Cab Harness Insulation, Installation CHU, CXU, GU, TD

FSB 371-048, Cab Harness Insulation, Installation

(October 2014)

W3093293

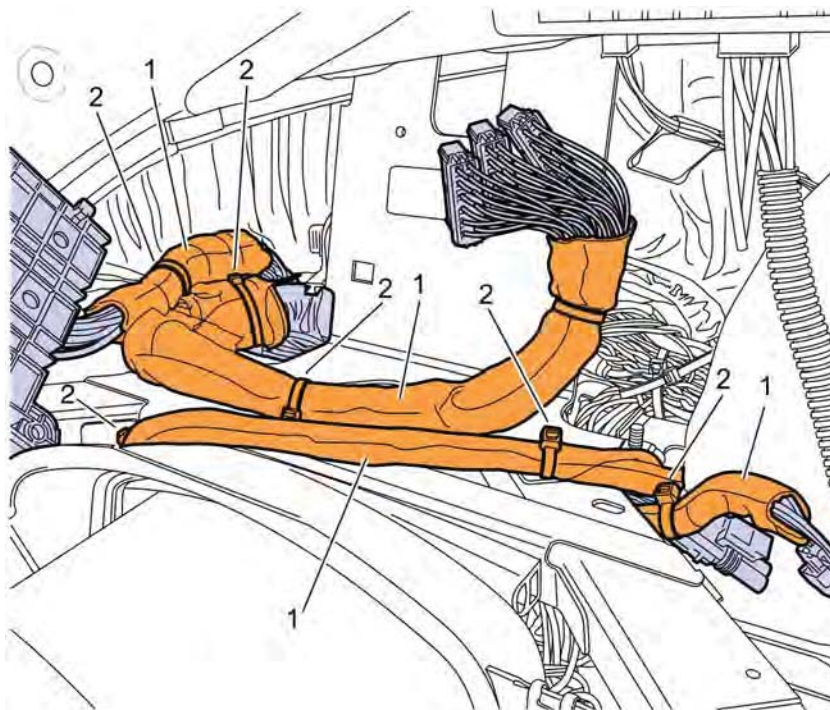
In some MACK CXU, CHU, GU, and TD trucks built between 01/01/2007 and 10/03/2014, the cab wiring harness may experience chafing in or around the steering column bracket. A self-wrapping insulation kit has been introduced to protect the cab wiring harness from chafing. The kit contains sections of insulation in 50 mm (2.0 in), 25 mm (1.0 in), and 13 mm (.5 in) diameter sizes. The insulation can be cut to desired lengths and wrapped around the harness areas in contact with the steering column bracket. Each section of insulation is secured using cable ties as needed.

W3093301

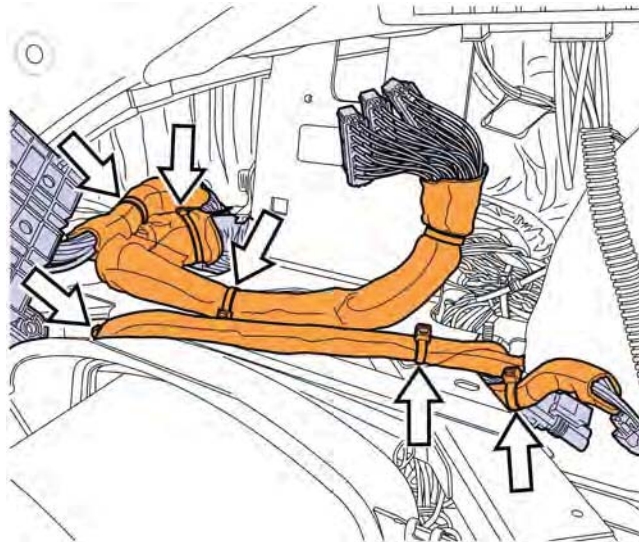
- 8 Wrap the insulation over the sections of harness in contact with the steering column bracket.
9 Secure the insulation with cable ties as needed.
